Replacement window details
Scale 1:5@A1
1:10@A3

Rev:				Client:			
A	Comments: Amendments as clouded.	By: KN	Date: Nov 25	Mr. Simon Dougall			
Project Title:				Drawing Title:			
107 High St, Lindfield, Haywards Heath, West Sussex, RH16 2HR				Replacement casement window - first floor south east elevation			
Scale:				Date:			
1:25@A1 1:5@A1 1:50@A3 1:10@A3				Apr 25			
Drawn:				Checked:			
KN				KW			
Project No.:				Drawing No.:			
900-25				5023			
Revision:				A

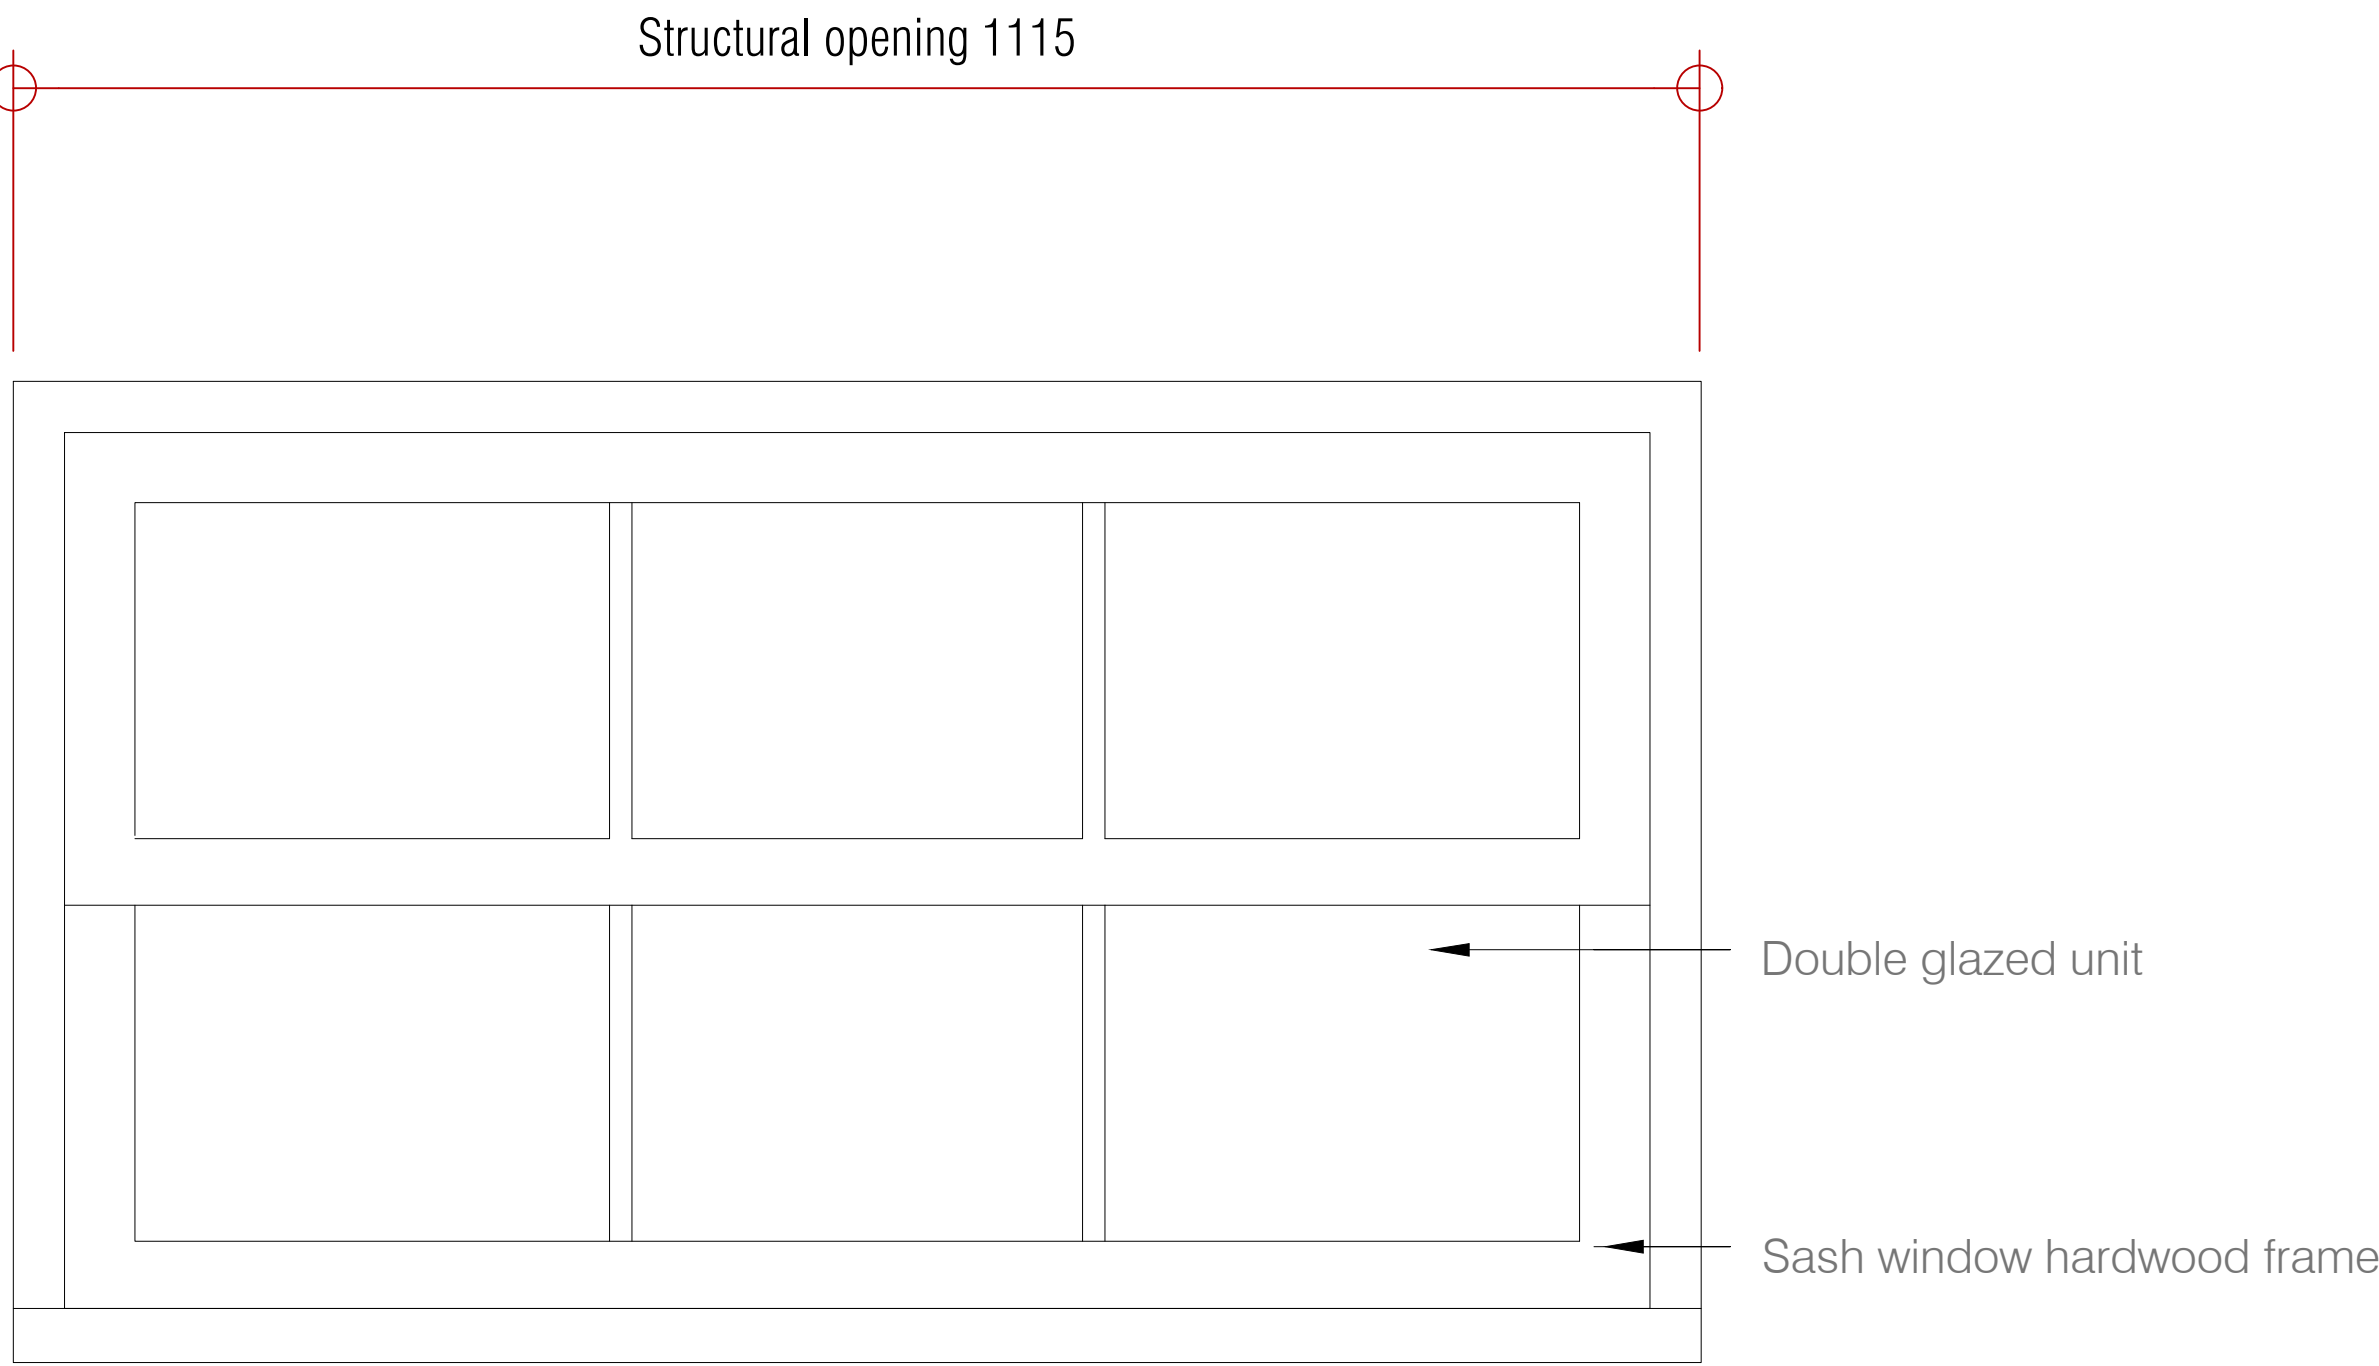
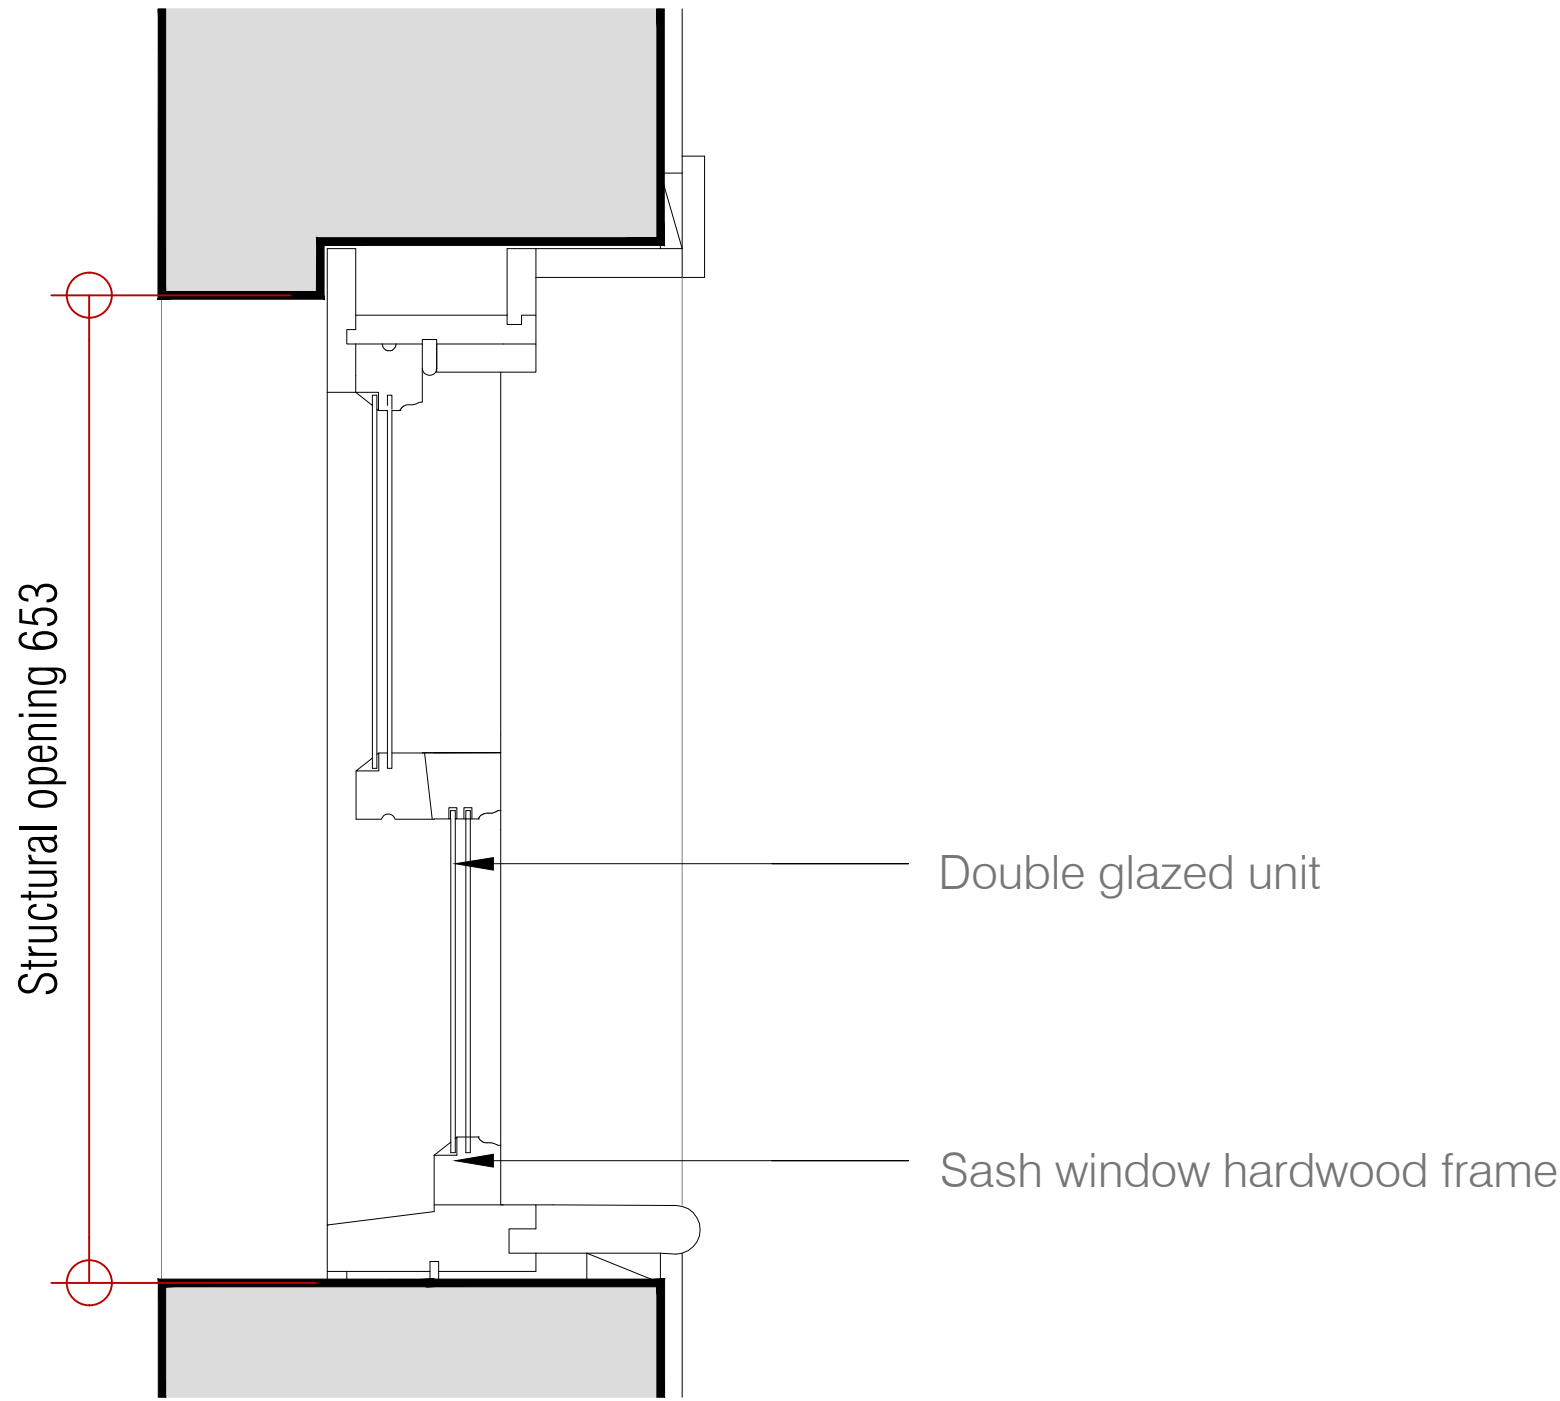
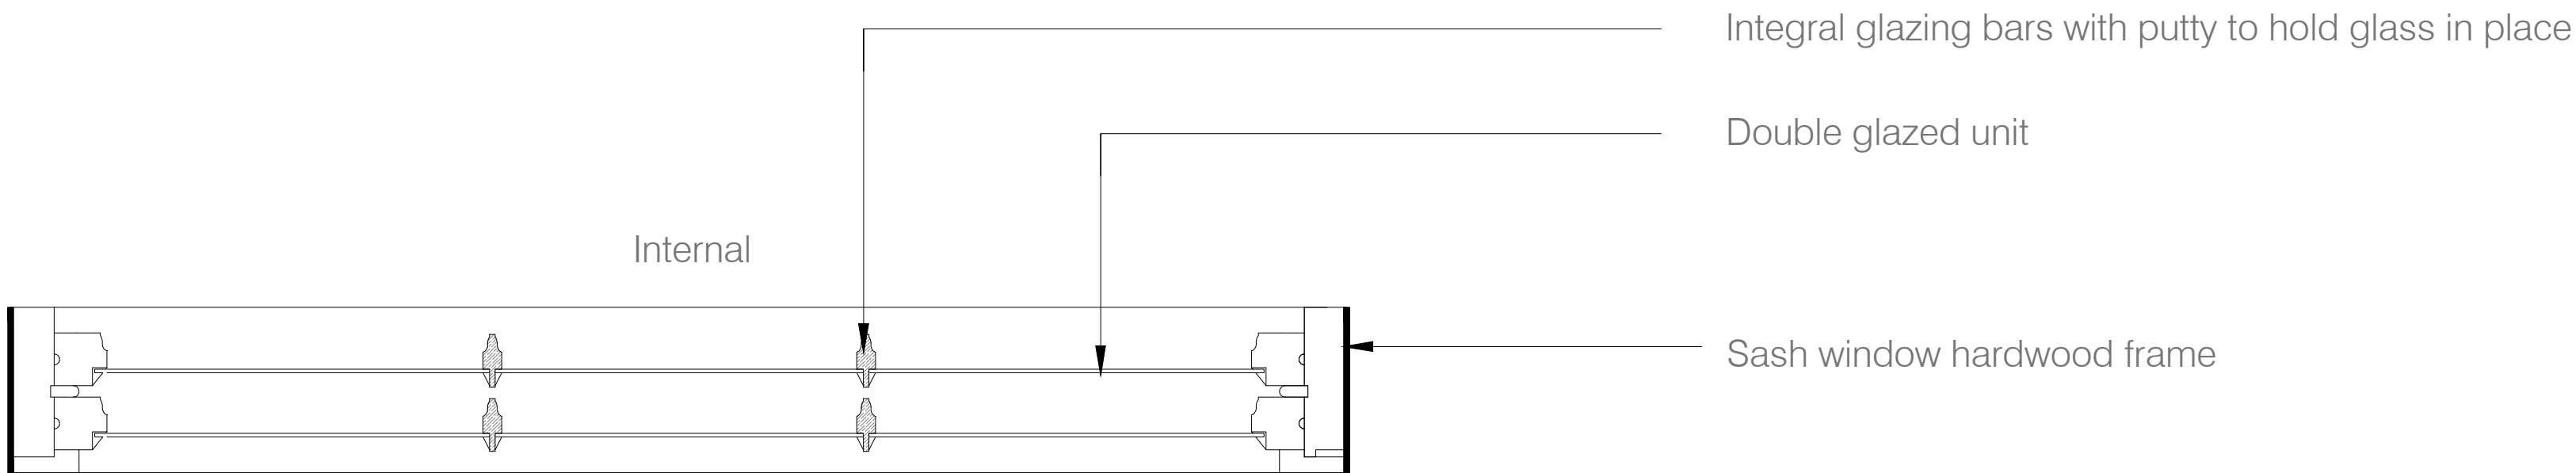
KEY:
Highlighted difference between Approved Scheme and 'As-Built'/Proposed Scheme
